**Shop Drawings  
Transmittal No:**

22 11 00-02R0

<b>Project Name:</b>	Construction of Victoria Park Arena and Brampton Sports Hall of Fame	<b>Project No.</b>	NRFP2024-232
		<b>DATE:</b>	20 Feb 2025
		<b>Submittal Required Return Date:</b>	06 Mar 2025
<b>Submittal No:</b>	36

<b>Title:</b>	SD-Buffer Tanks
---------------	-----------------

MECHANICAL EQUIPMENT SCHEDULES #2	
SHEET NUMBER:	
M-901	
OF	
ISSUE:	REV/#
ISSUED FOR TENDER	8
DATE OF: 2024/05/29

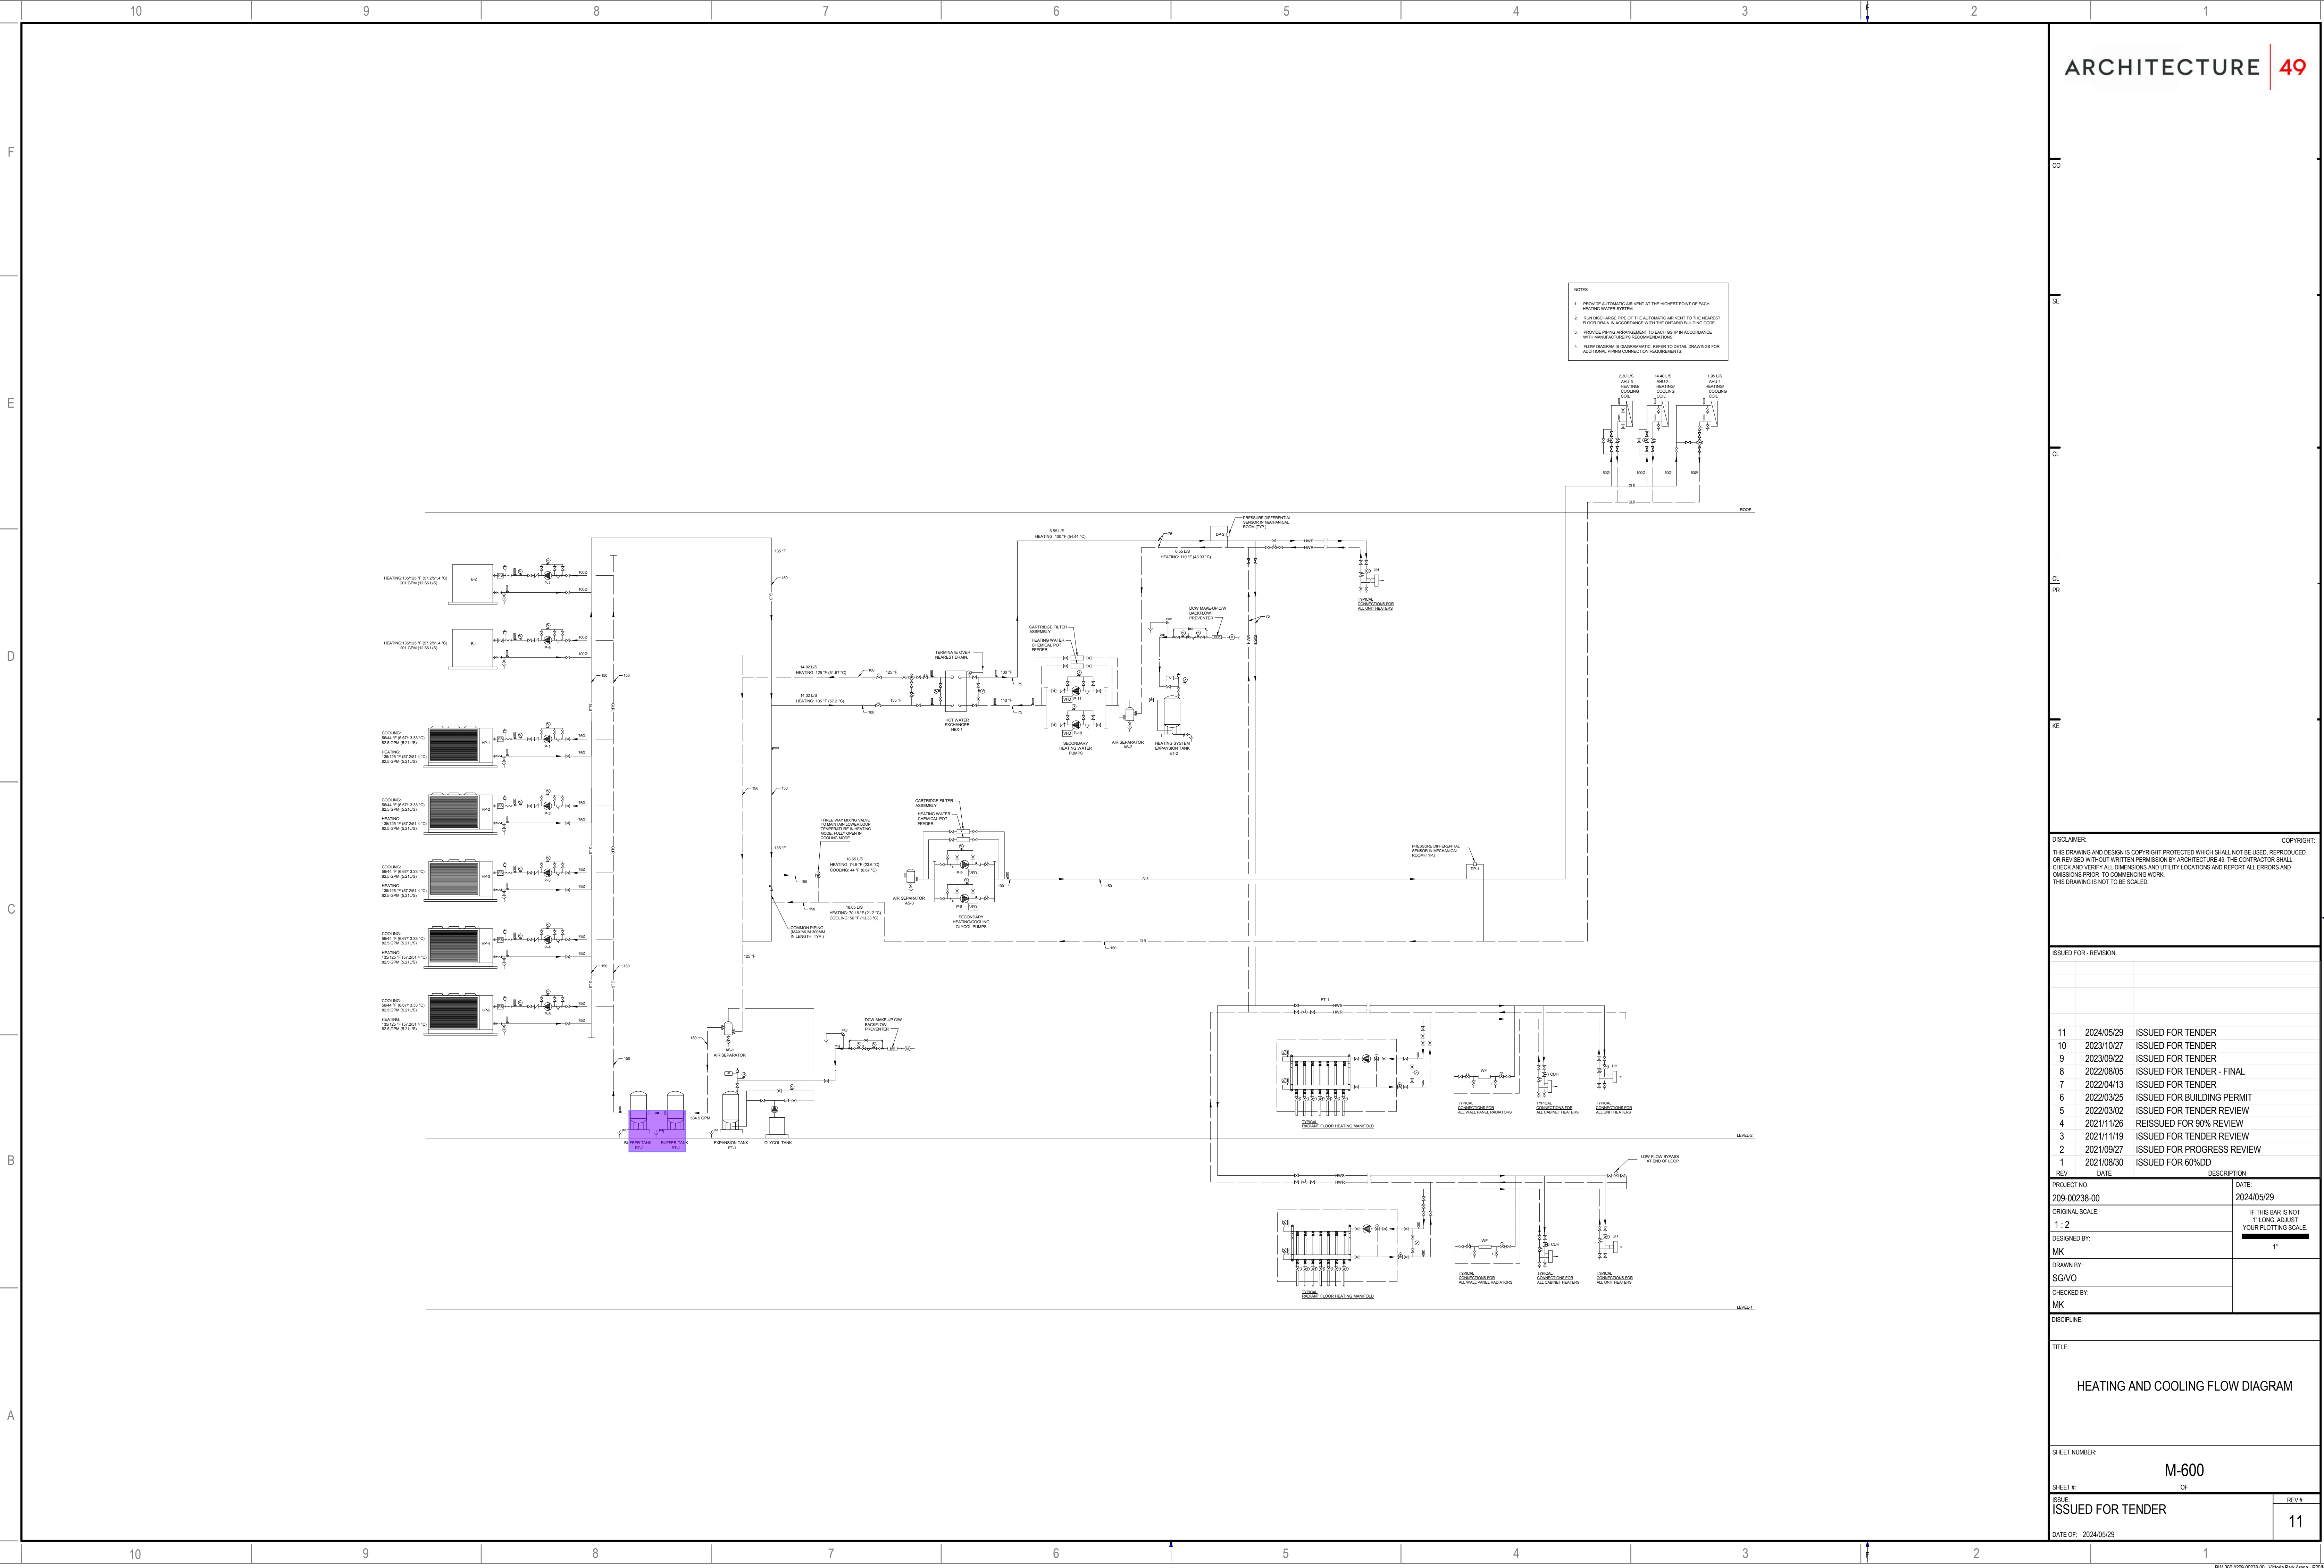
<input type="checkbox"/> Reviewed	<b>Mechanical Review Required</b> <input checked="" type="checkbox"/>	<b>Electrical Review Required</b> <input type="checkbox"/>
<input checked="" type="checkbox"/> Reviewed as Noted	<b>Reviewed by:</b> Jerry Nweisser	<b>Reviewed by:</b>
<input type="checkbox"/> Revise & Resubmit	<b>Review Date:</b> 2025-03-05	<b>Review Date:</b>
<b>Item</b>	<b>Comments</b>	
1.	Contractor to ensure that buffers tanks are c/w thermal insulation as noted in buffer tank schedule note #1.	
2.		
3.		
4.

NOTES:  
1. CW THERMAL INSULATION
